QUARANTINE NOTICE

Reference number:	QN-01-1664	Issued: 11 July, 2022
Subject:	Lightweight Seat Latch	
Model(s):	V12 Vantage, Vantage F1, Vantage F1 Roadster	
VIN Range:	Refer to the separately published list of affected Vehicle Identification Numbers (VINs)	
Applicable to:	UK, Europe, North America, APAC	
Distribute to:	After Sales Manager Executive Manager Service Manager Sales Manager	Warranty Staff Technician(s) Parts Staff

Reason for this Quarantine Notice

Figure 2

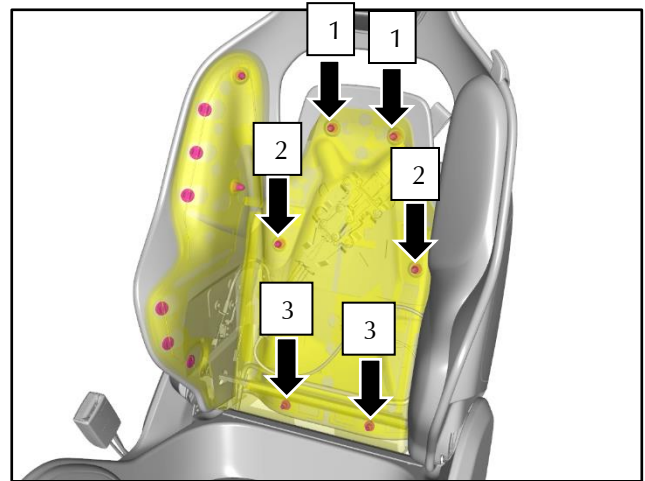
1. Use a forked trim removal tool to release the ball and socket fixings for the centre pad in the order shown (refer to Figure 2).
The fork should be pushed between the ball and socket to release.

CAUTION: CARE MUST BE TAKEN WHEN YOU PULL AWAY FROM THE POST BASE AND RUBBER SOCKET. IF TOO MUCH FORCE IS APPLIED THE FIXINGS CAN BE DAMAGED.

Figure 3

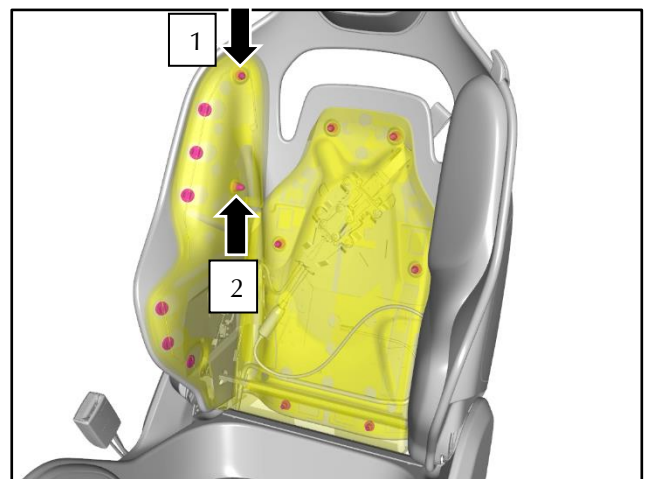
2. Use a forked trim removal tool to release the ball and socket fixings for the side pad in the order shown (refer to Figure 2).

CAUTION: CARE MUST BE TAKEN WHEN YOU PULL AWAY FROM THE POST BASE AND RUBBER SOCKET. IF TOO MUCH FORCE IS APPLIED THE FIXINGS CAN BE DAMAGED.

Figure 4

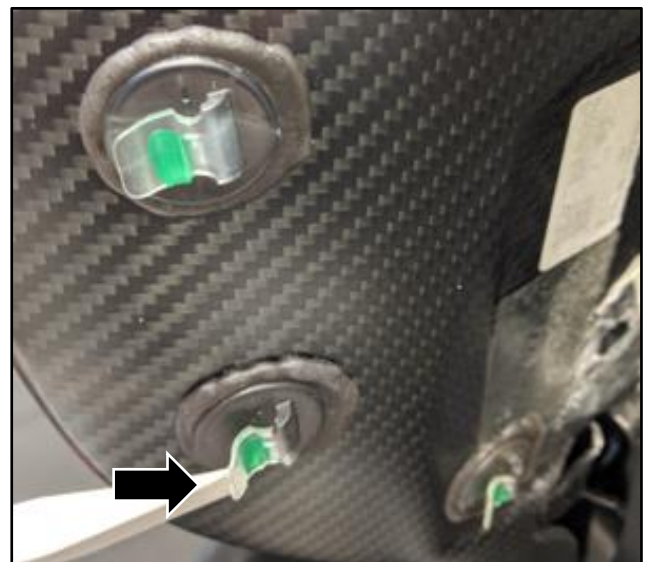
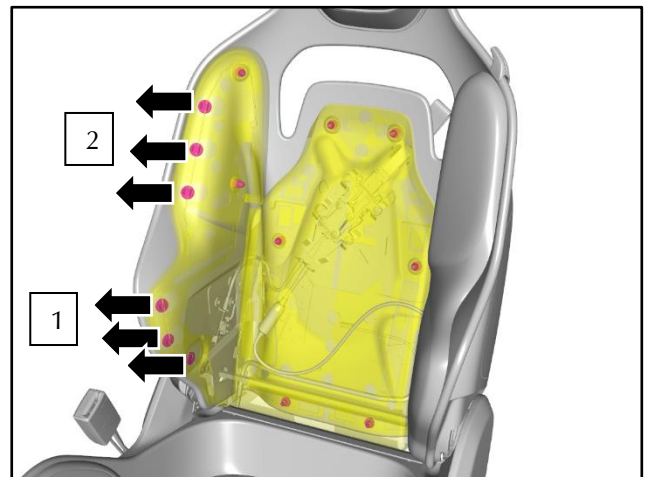
3. Release the seat pad from the clips in the order shown (refer to (Figure 4)).

Note: *When you install the seat pad, start in the opposite order.*

CAUTION: CARE MUST BE TAKEN WHEN YOU RELEASE THE CLIPS. IF TOO MUCH FORCE IS APPLIED THE CLIPS CAN BE DAMAGED.

Figure 5

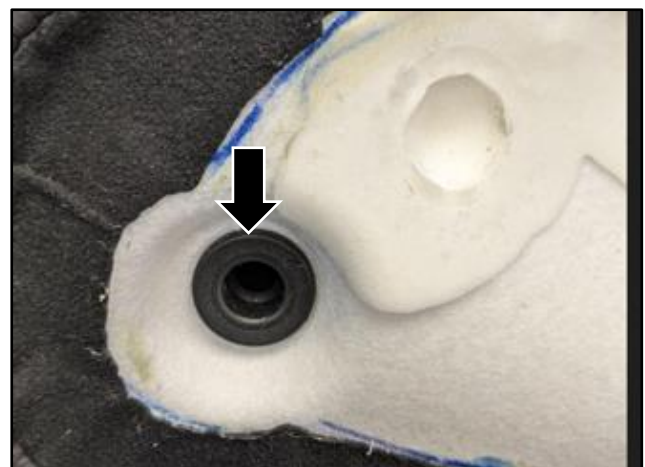
4. If a rubber bush socket is removed it must be installed to the seat pad again (refer to Figure 5).
 1. Apply Loctite 406 (or other suitable adhesive for use with rubber) around the top of the bush socket.
 2. Let the adhesive dry for a minimum of 15 minutes before you install the rubber bush socket.
 3. Install the rubber bush socket.

Figure 6

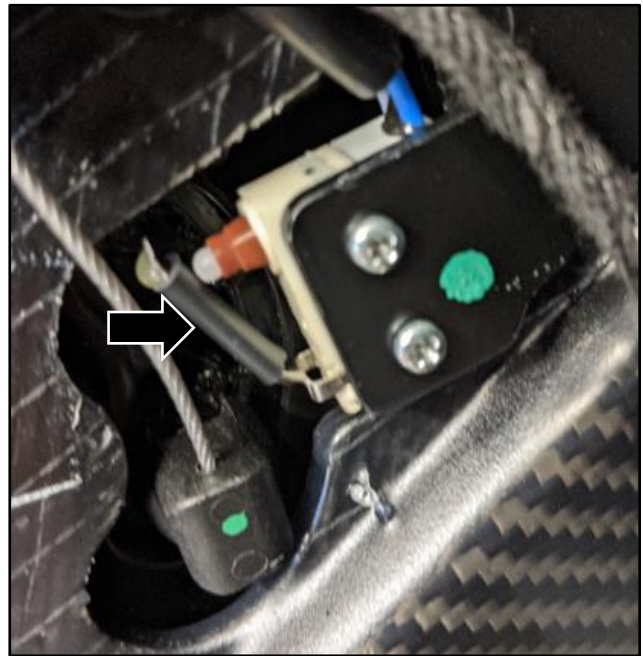
5. Install a 12-15mm piece of adhesive lined heat-shrink around the microswitch lever for the seat latch (refer to Figure 6).

6. Use a heat gun with a fine nozzle to shrink the adhesive lined heat-shrink.
CAUTION: MAKE SURE YOU DO NOT HEAT STRESS THE SURROUNDING COMPONENTS. PARTICULAR CARE MUST BE TAKEN NEAR THE MICROSWITCH PLUNGER. USE A SMALL PIECE OF ALUMINIUM FOIL TO DEFLECT HEAT AND PROTECT COMPONENTS FROM THE HEAT GUN.
7. Let the heat-shrink cool for 3 to 5 minutes.
8. Test the operation of the seat latch switch as in Part A to make sure the warning message shows in the instrument cluster.
9. Do steps 1 through 3 in the opposite order to install the seat pad.
